802.3dj D1.2

Comment Resolution

Electrical Track

Adee Ran (Cisco), 802.3dj Electrical Lead Editor
Matt Brown (Alphawave), 802.3dj Chief Editor
Howard Heck (TE), Editor, Clause 178 and Annex 176C

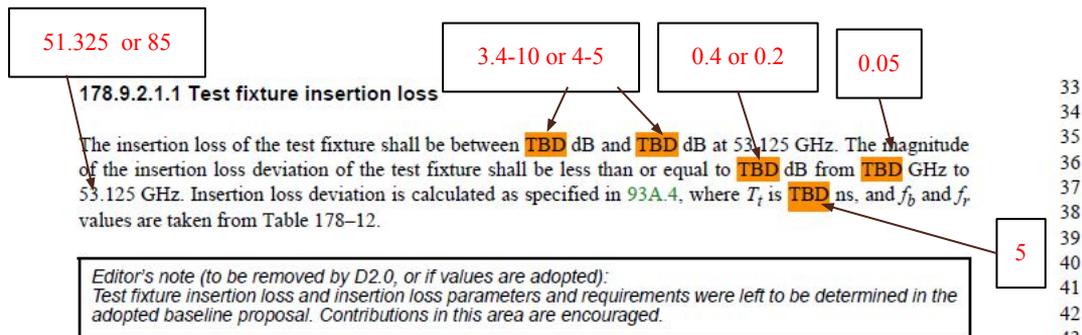
Use:

ILdd between 3.4 dB and 10 dB at 53.125 GHz
ILD magnitude up to 0.4 dB from 0.05 GHz to 53.125 GHz
 T_t is 0.005 ns

PROPOSED ACCEPT IN PRINCIPLE.

The comment addresses an open TBD and the comment and the suggested remedy are reasonable, but consensus is not obvious.

Figure 178-8—Channel mode conversion insertion loss to insertion loss difference

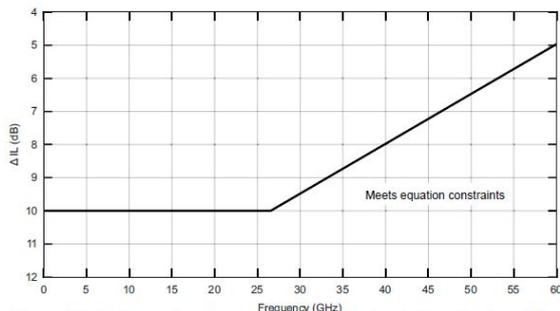
CI 179 SC 179.11.5 P375 L15 # 102
 Ran, Adeo Cisco Systems, Inc.
 Comment Type TR Comment Status D CA specifications

In 802.3ck the specification of this parameter are the same in KR (163.10.5) and CR (162.11.5). Therefore we can use the same equation and figure as in KR (178.10.5).

Rename the parameter to "mode conversion insertion loss" and use the same equation and figure as in 178.10.5. Implement with editorial license.
 Change the reference in the text to point to the correct equation and figure.

Proposed Response Response Status W
 PROPOSED ACCEPT.
